Kewaunee Nuclear Power Plant  
Docket No. 50-305  
Operating License DPR-43  
Request for Additional Information Concerning Your  
Review of "Qualification of Reactor Physics Methods  
for Application to Kewaunee"

RESPONSE TO REQUEST FOR ADDITIONAL INFORMATION

QUALIFICATION OF REACTOR PHYSICS METHODS

KEWAUNEE NUCLEAR POWER PLANT

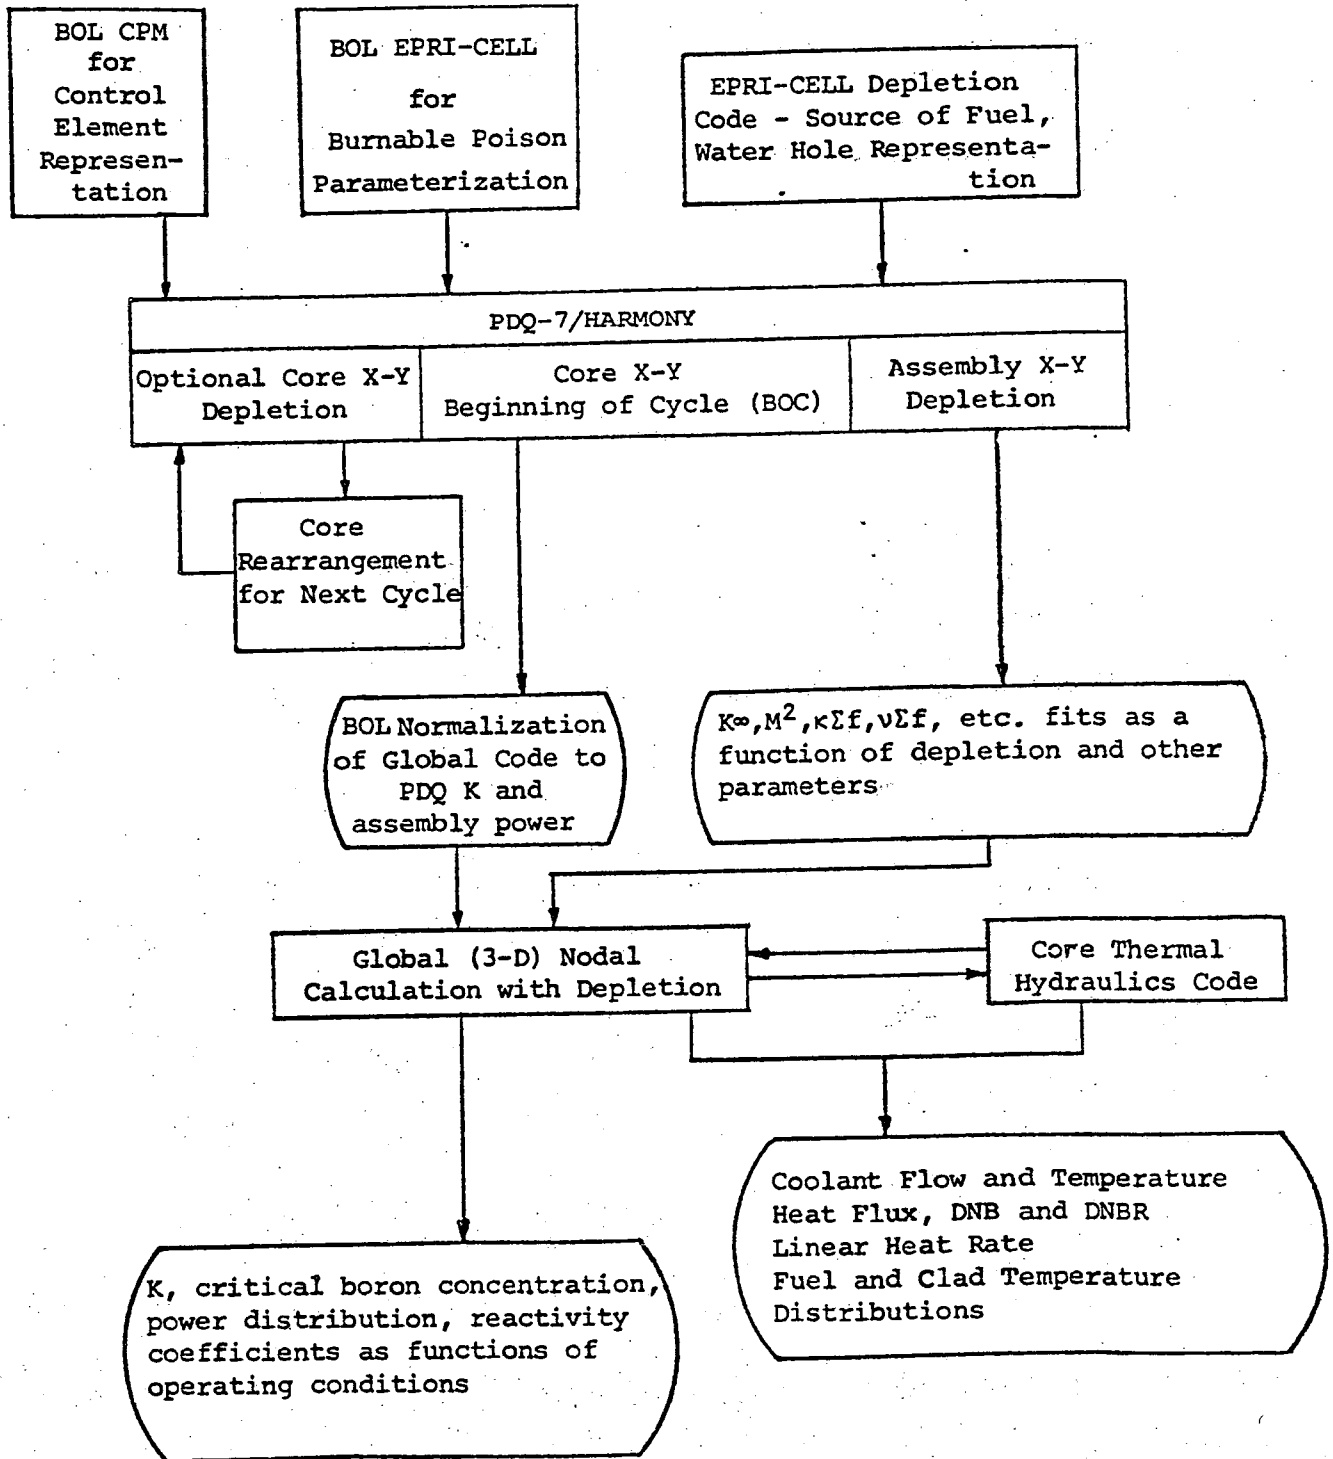
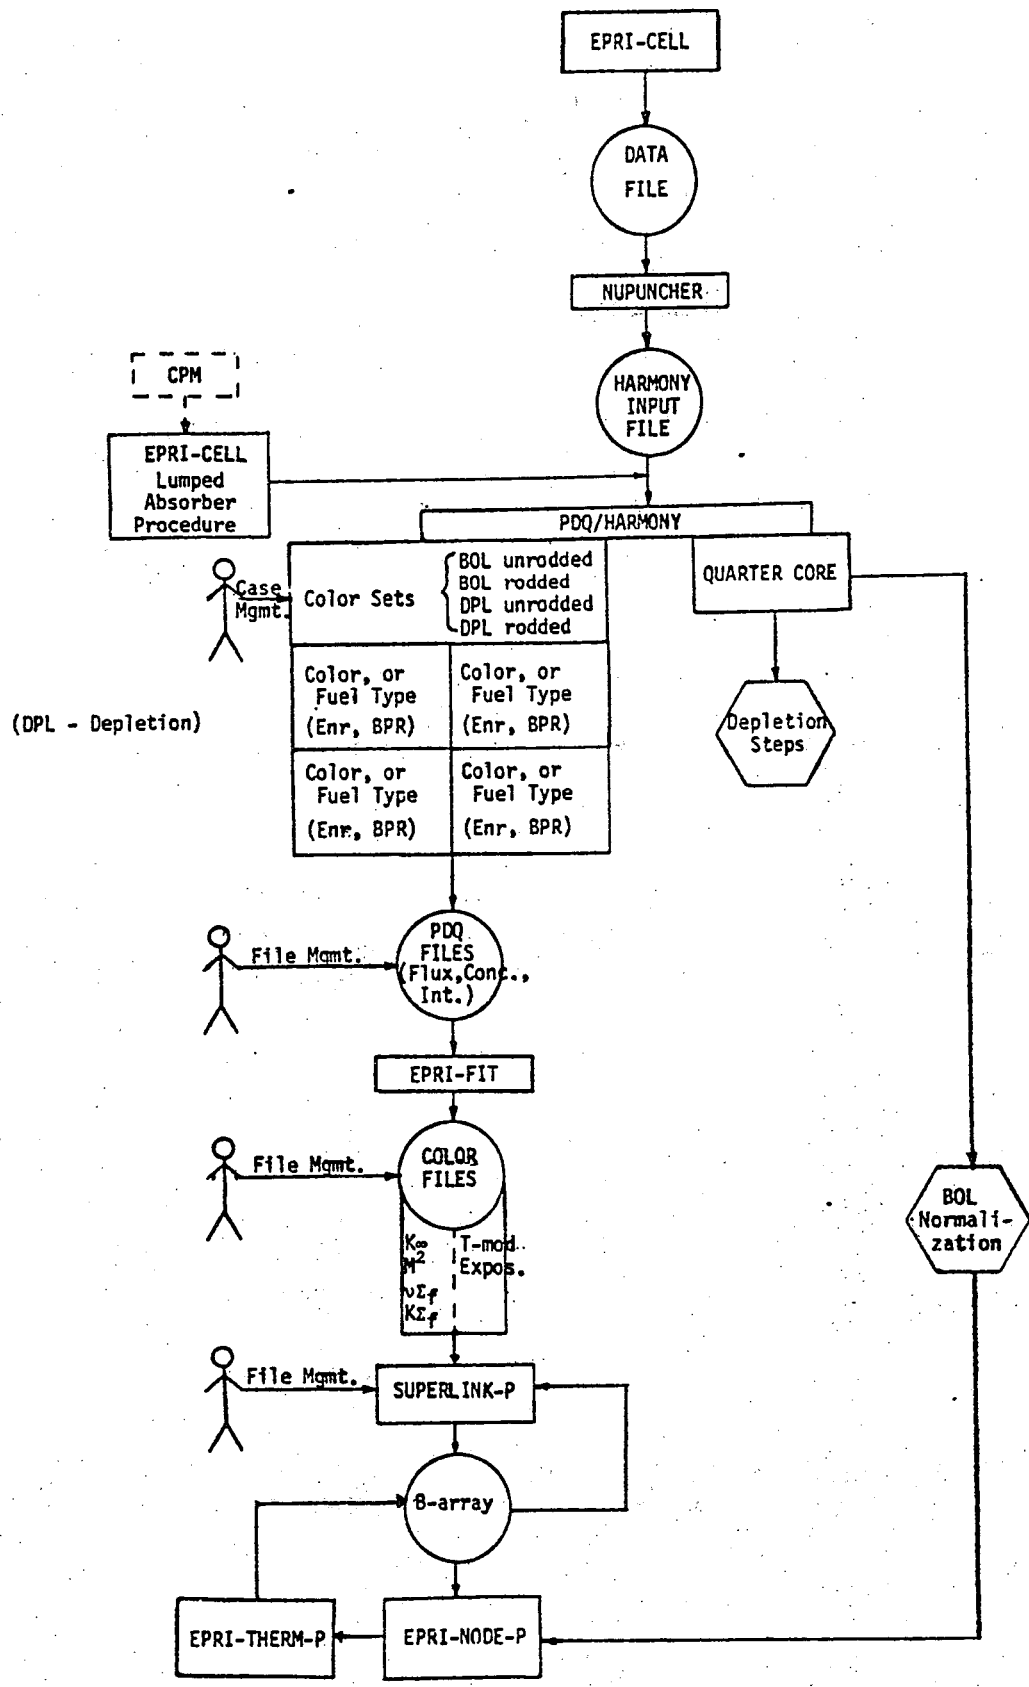
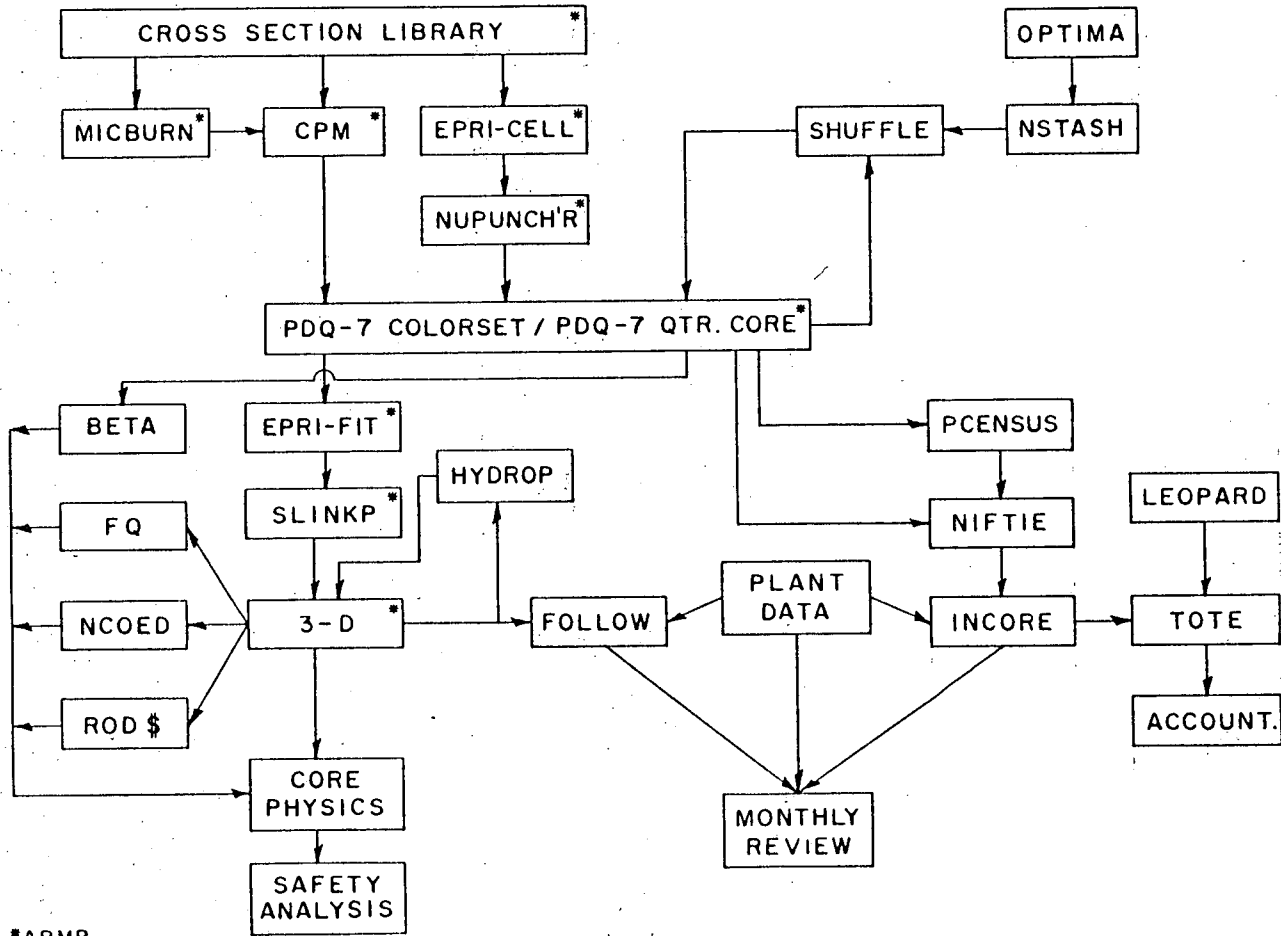
1. Describe in more detail the specific ARMP calculational procedures used for each physics parameter calculated, i.e., an expanded version of Figure 2.1 and App. B of your qualification report.

Response: *Attachment A to this enclosure contains the WPS Core Analysis System Description. This description identifies the codes employed, the flow path and methodology employed to transfer and utilize data to and from the various codes, the resulting output, and the pertinent physics parameters of the various stages. This description is an expansion of the summary presented to members of the NRC staff during our November 1, 1978, meeting.*

This information will not be repeated in any detail here, however, the flow chart diagrams presented in figures 1 and 2 illustrate the model data flow and the calculational flow respectively.

A simplified diagram of the WPS implementation of the ARMP model is presented in Figure 3.
